REPORT TO THE CALGARY PLANNING COMMISSION

DEVELOPMENT PERMIT	ITEM NO: 14	
	CPC DATE:	2007 March 22
	DP NO:	DP2006-3835

PROPOSAL:
New Apartment Building (100 units)

A2-04

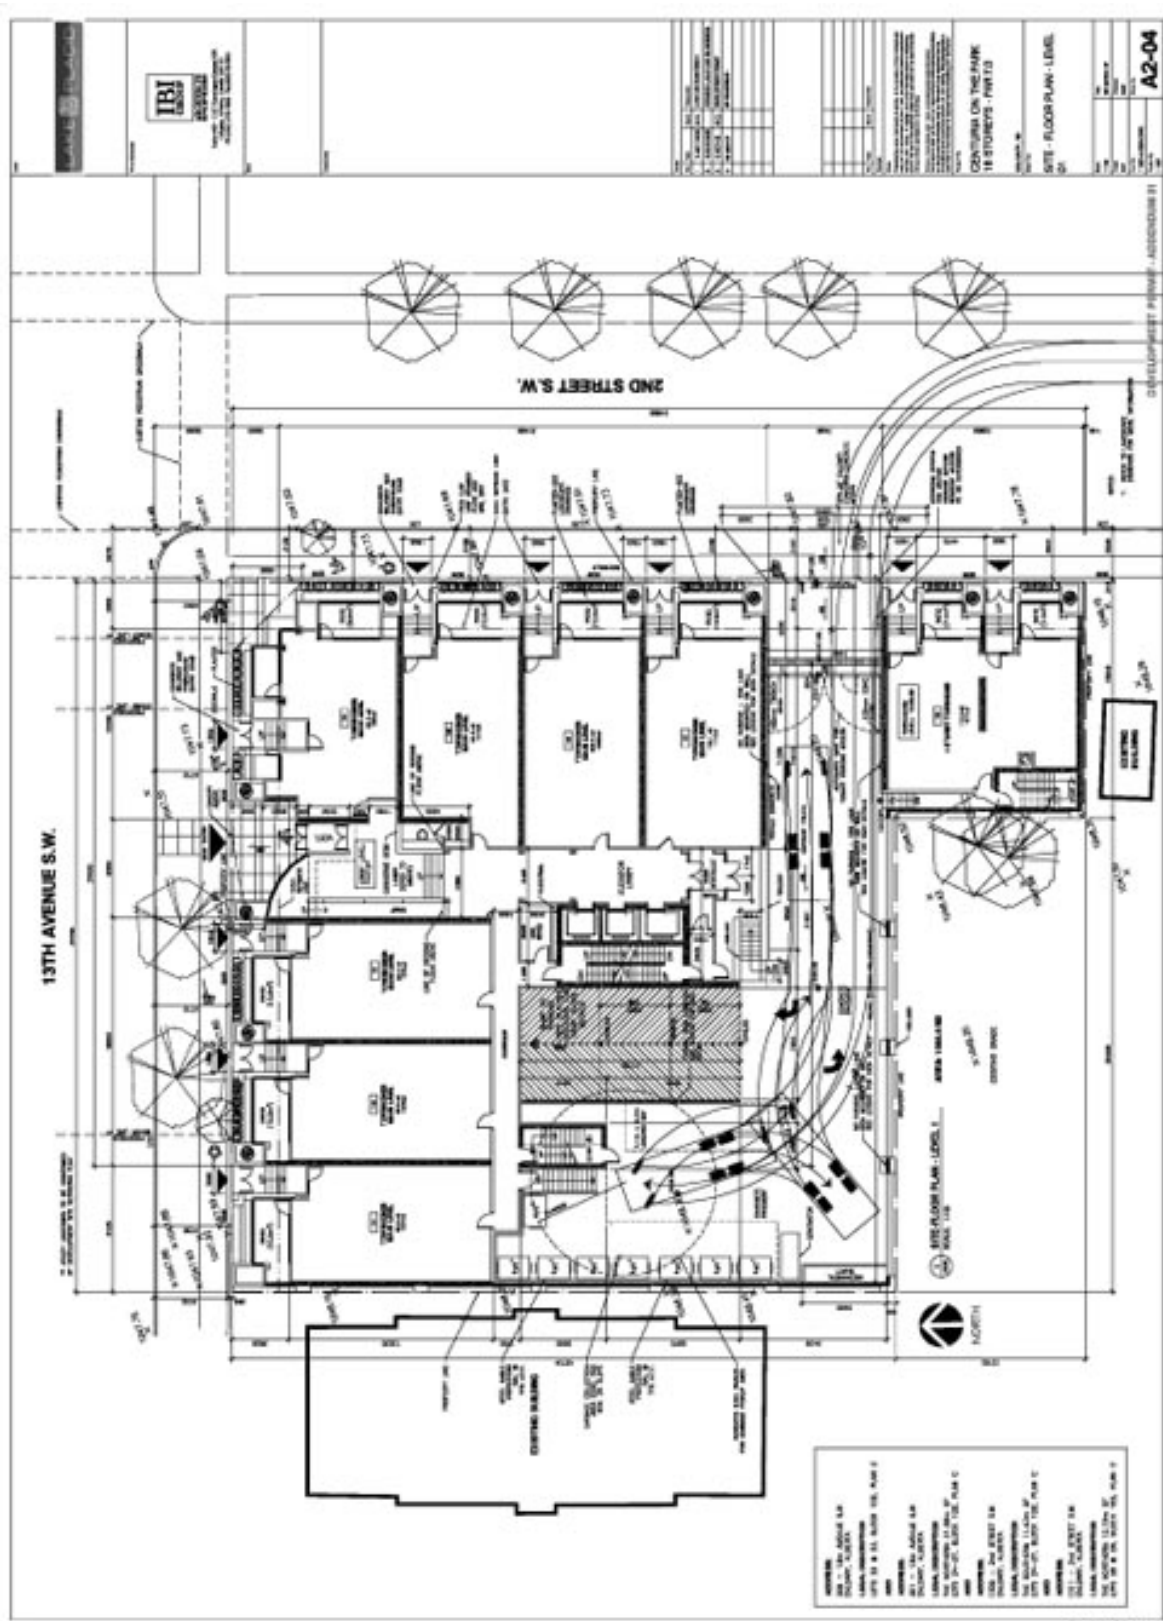
14. Sheet A2-04 makes reference to a legend for signage. Transportation did not see the legend provided; please provide a copy;
15. Areas within the parkade that are not intended to be parking areas (such as outside doorways) should be hatched with paint and signed "NO PARKING" to prevent motorists from attempting to use them as stalls. Indicate this on the drawings of the parkade levels;
